Public Works Department – Engineering Division

ADDENDUM NO. 3

PROJECT 5067 WTP FILTER IMPROVEMENTS AND HYPOCHLORITE CONVERSION

DWG. NO.
GC004

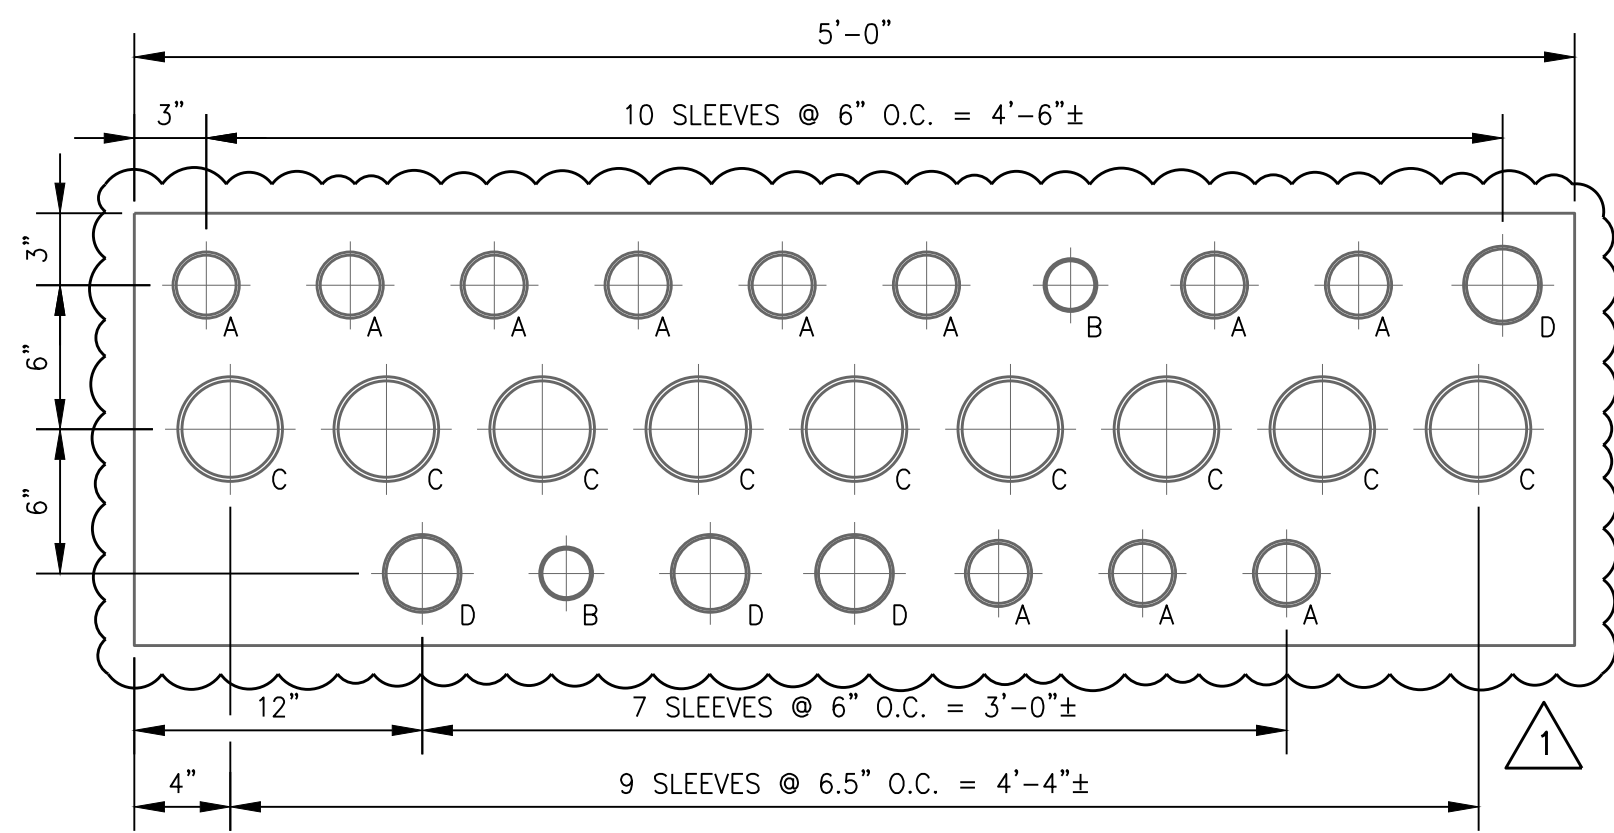
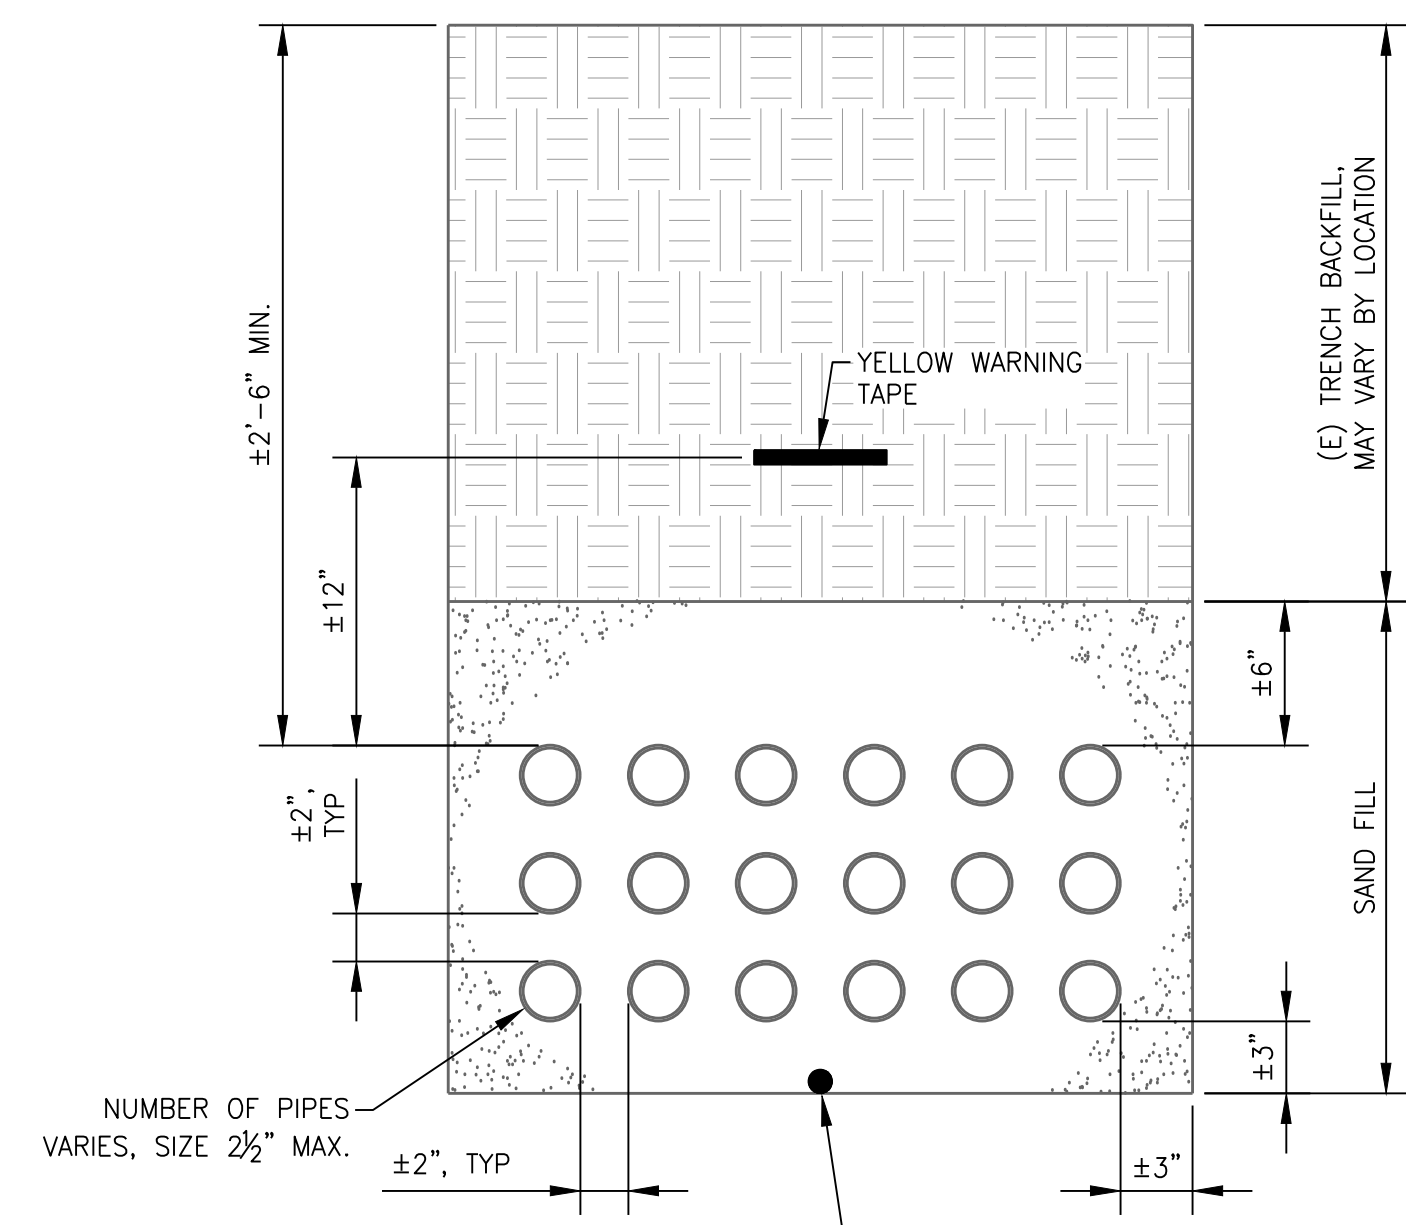
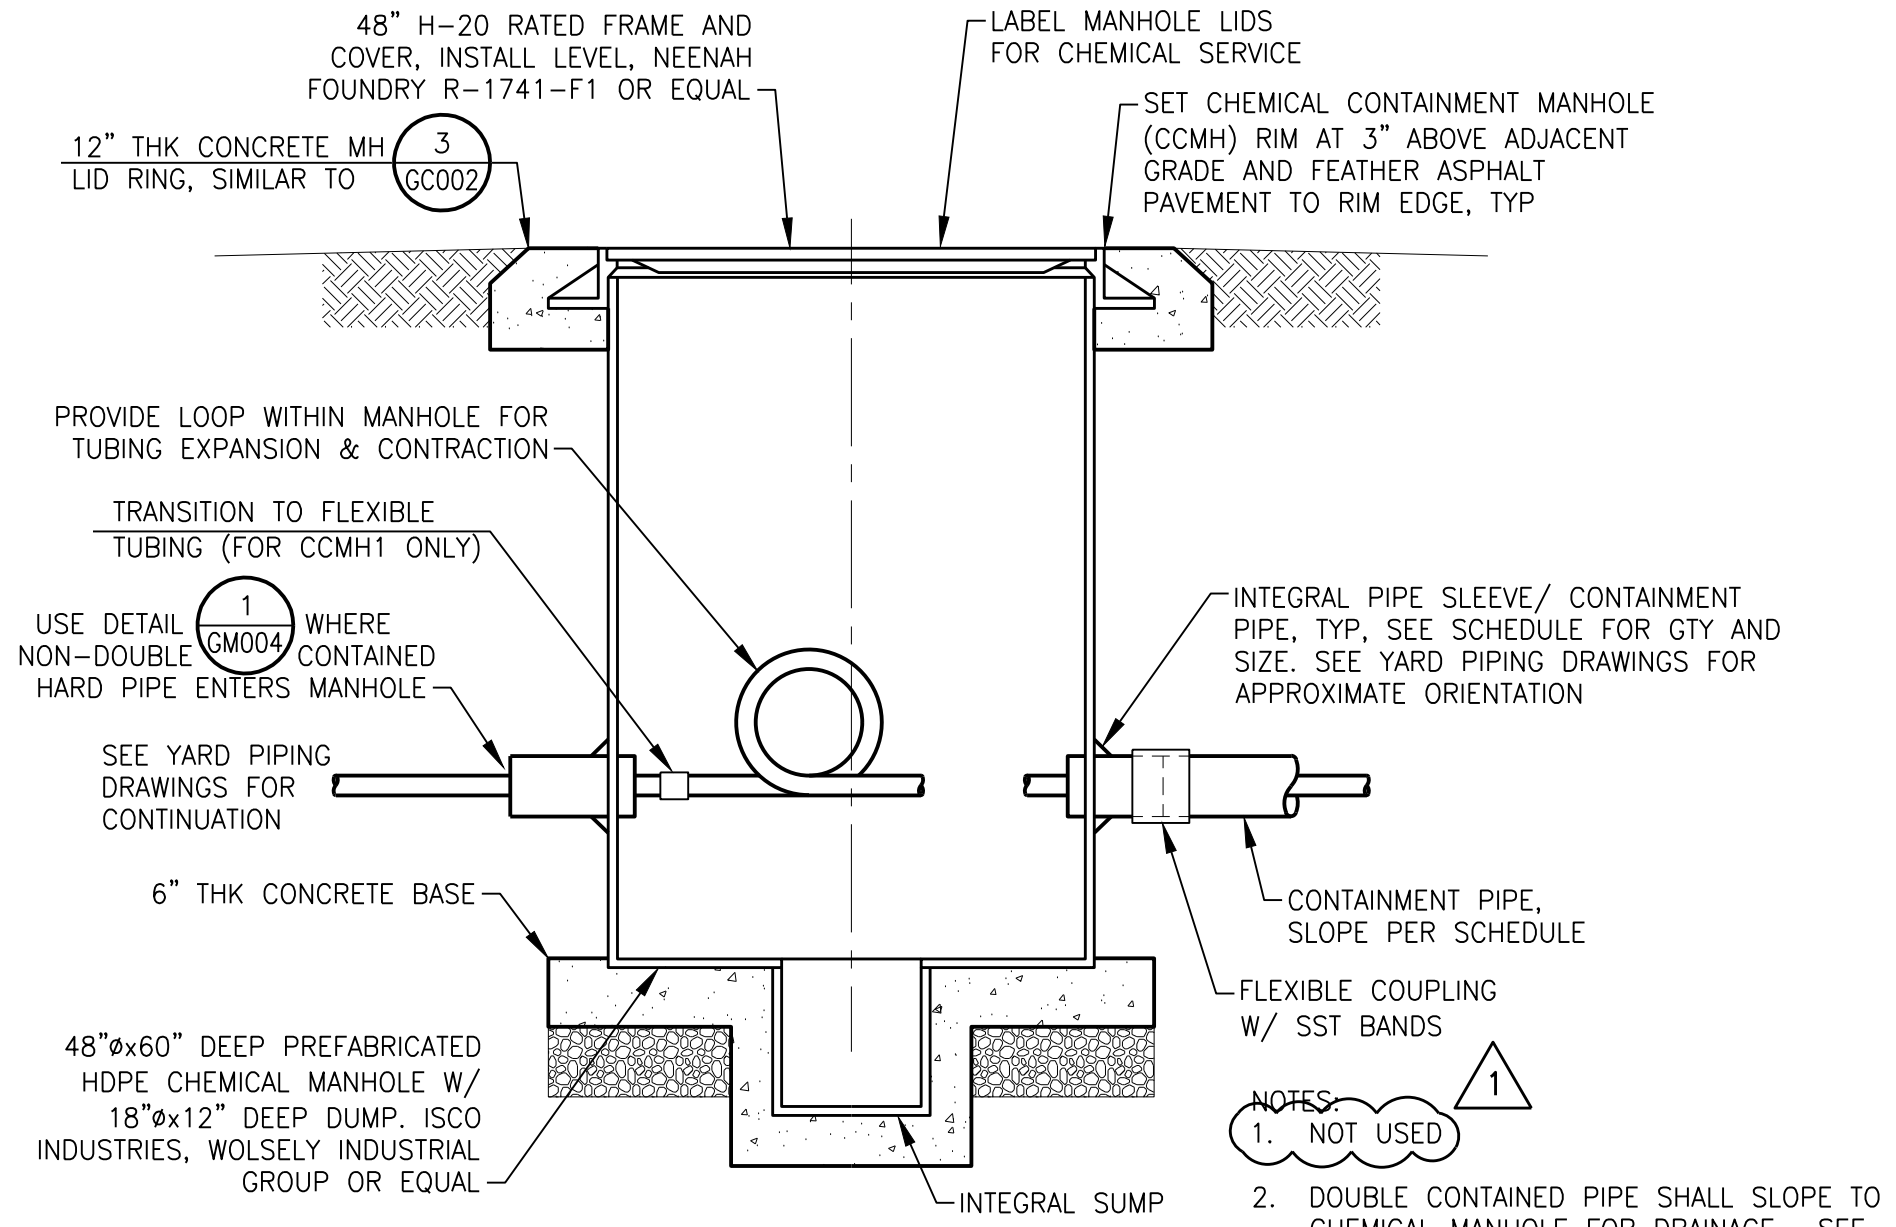
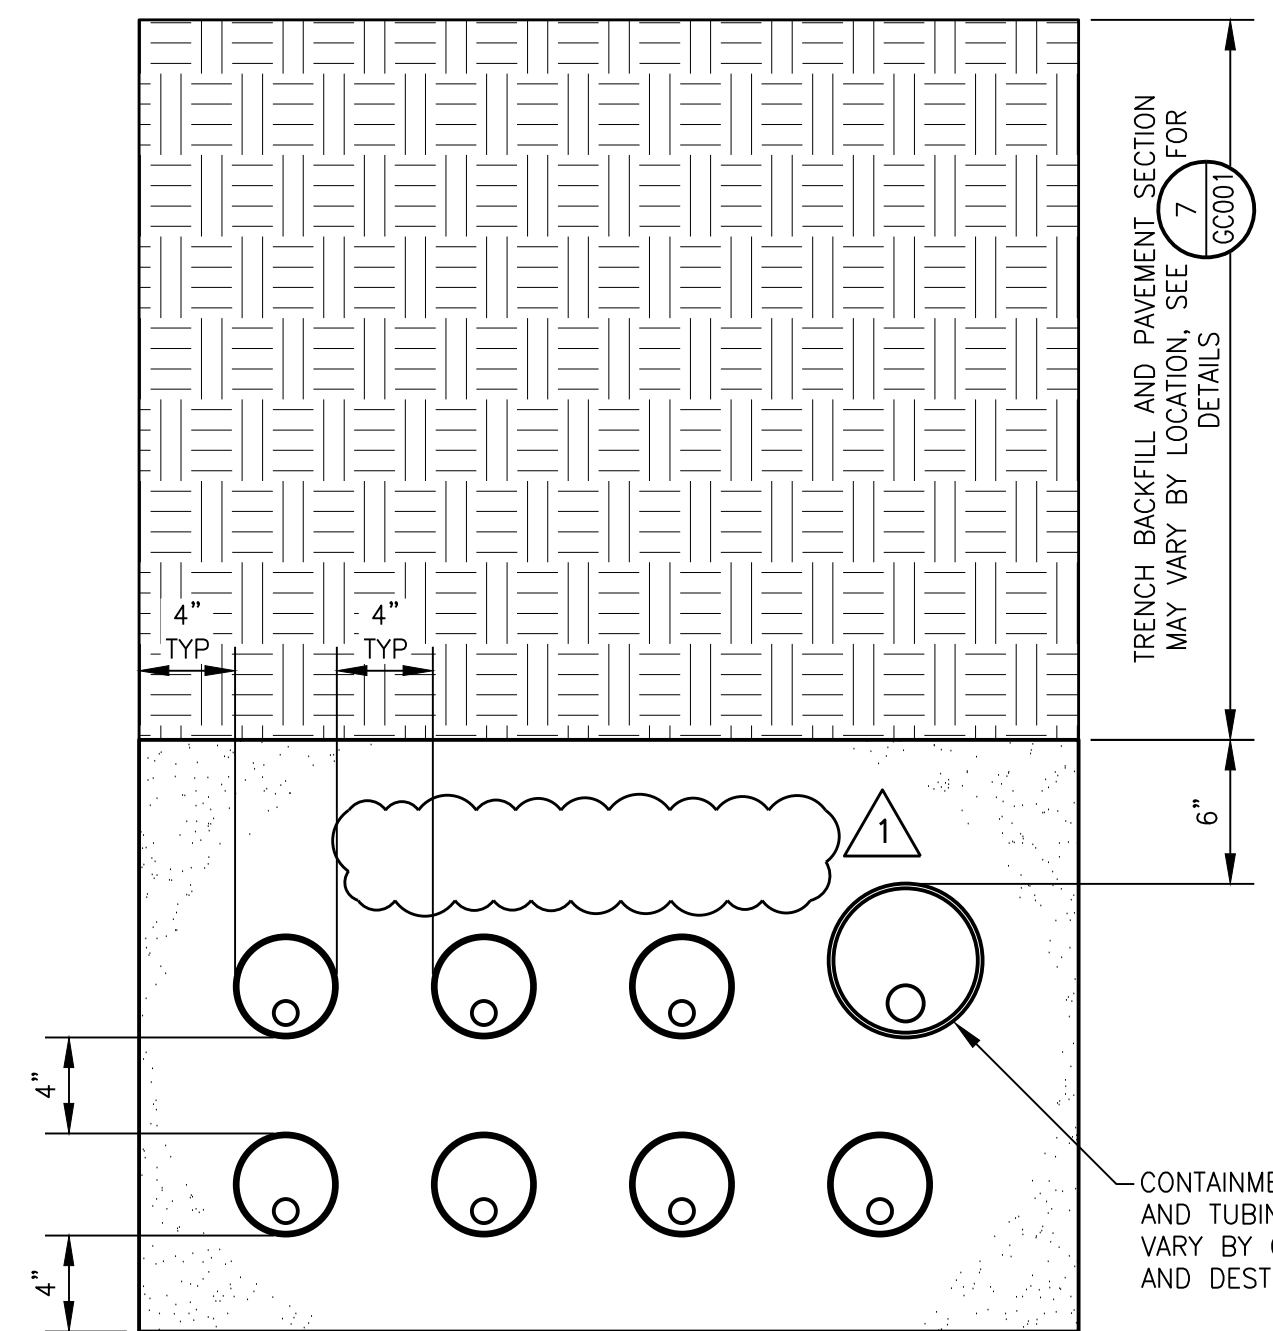
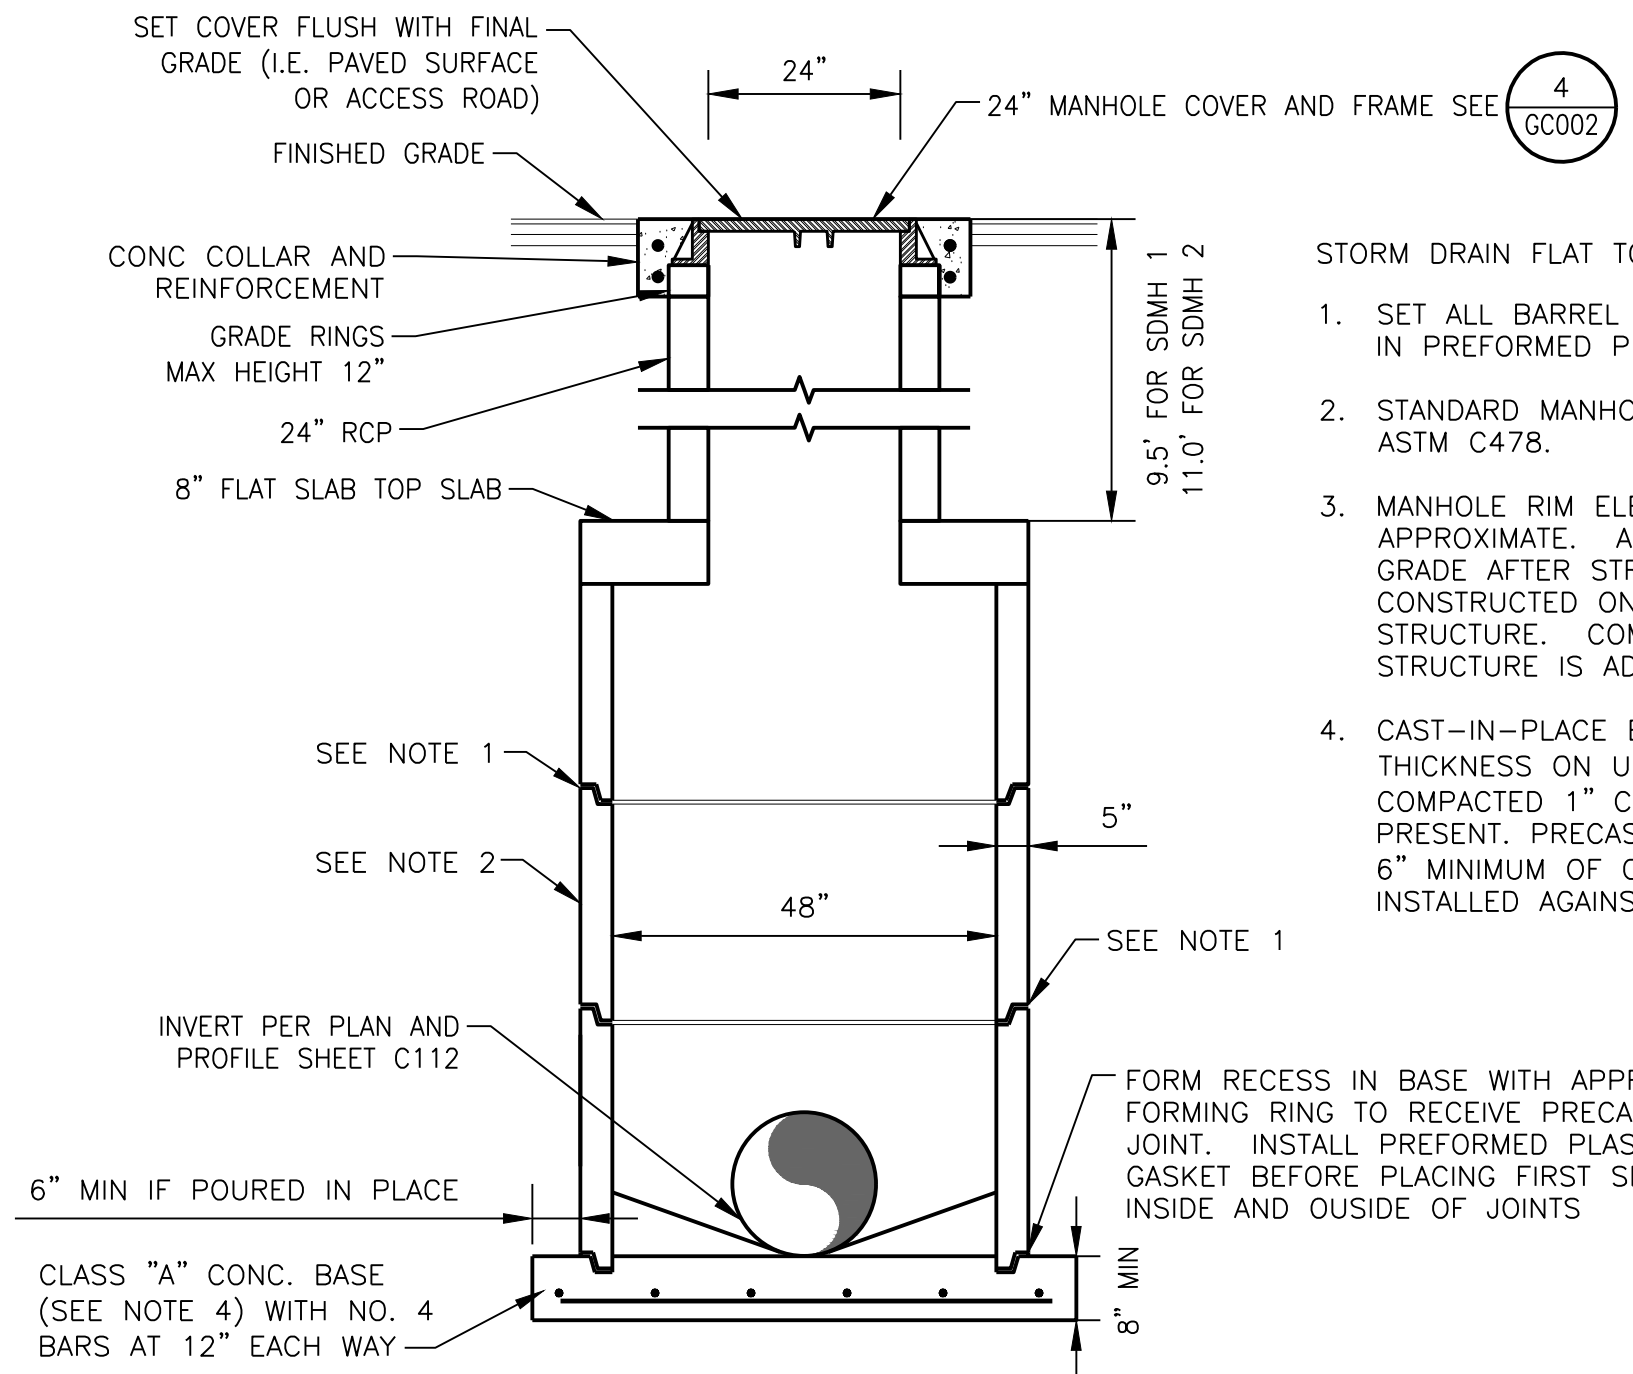
14. Replace Drawing GC004 with the attached revised Drawing GC004.
15. On Drawing C105, change the far-right callout "#5" connection to "#3" for the 30" PS2 Discharge.

30. There is a call out on the (n) Joint Trench north of the chemical manhole for a 6" SHC on C102 and does not match the sizing on the Chemical Containment Manhole Table Detail 4 on sheet GC004. Please confirm that containment pipe is meant to be 4".

36. Drawing C102 shows a new joint trench with six (6) dual contained HDPE chem lines & three (3) PVC sample lines running from the operations building to CMH#1. Detail 6 on drawing GC004 shows eight (8) existing chem lines running from the operations building to CMH#1. And P&ID I360 appears to have six (6) chem lines running through CMH#1 but not all of the systems match drawing C102. Please provide clarification/detail for the correct routing of new & existing chem lines into CMH#1, as well as the routing of the chem lines within CMH#1.

Response: New double-contained chemical piping will only be required, for new and modified chemical systems, downstream of the tie-in with existing piping upstream of new Chemical Containment Manhole No. 1. New sample lines may occupy joint trench with chemical lines where practical but need not go through chemical containment manholes (and may wrap around them as needed). See this addendum, Item A.13. and A.14 for revised drawings C102 and GC004. Drawing I360 will be updated as part of Addendum 4.

Response: New double-contained chemical piping will only be required for new and modified chemical systems and downstream of the tie-in with the existing piping upstream of new Chemical Containment Manhole No. 1. New sample lines may occupy joint trenches with chemical lines where practical but need not go through chemical containment manholes (and may wrap around them as needed). See this addendum, Item A.13. and A.14 for revised drawings C102 and GC004. Drawing I360 will be updated as part of Addendum 4.

Response: No, the new chemical containment manholes need not be coated, as the required material, HDPE, is resistant to corrosion. Refer to callout indicated HDPE material in Detail 4, Drawing GC004.
